AMENDMENTS TO THE DRAWINGS

REMARKS

Application No. 10/583,966 Amendment dated May 10, 2011 Reply to Office Action of February 11, 2011 Docket No. 0649-1323PUS1 Art Unit: 3679 Page 28 of 28

found, for example, in **FIGS. 2-4.** (FIG. 4 is shown below.)

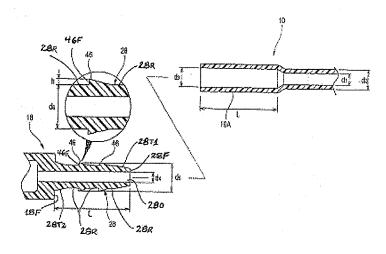
In response the Examiner's assertion that it is not proper to recite from "the ring-shaped end face 28F on a tip end 28T of the press-fitting portion 28" in claim 1, and as illustrated in FIG. 4, one sheet of Replacement Drawings (FIG. 4) is attached at the end of this paper in order to delete reference numeral "28T." No new matter has been added.

As can be seen in FIG. 4 above, the present invention as set forth in each of independent is limited to only two truncated-conical-shaped annular projections (namely, a first truncated-conical-shaped annular projection).

One sheet of Replacement Drawings (FIG. 4) is attached at the end of this paper in order to delete reference numeral "28T." No new matter has been added.

As can be seen in Kodama et al. FIG. 1 below,

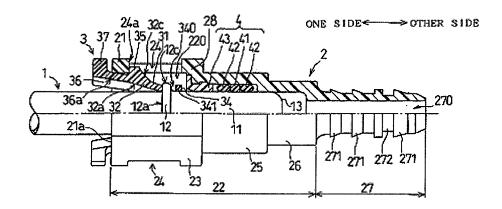
the hose connector 27 of Kodama et al. fails to disclose the "an exterior of the press-fitting portion consists of the following portions along an axial length L thereof," as set forth in independent claims 1, 8, and 17 as amended. For example, as can be seen in Kodama et al. FIGS. 1 and 3, this document discloses three steps 271, and a U-shaped sealing groove 272 adjacent to a cylindrical portion on hose connector 27.
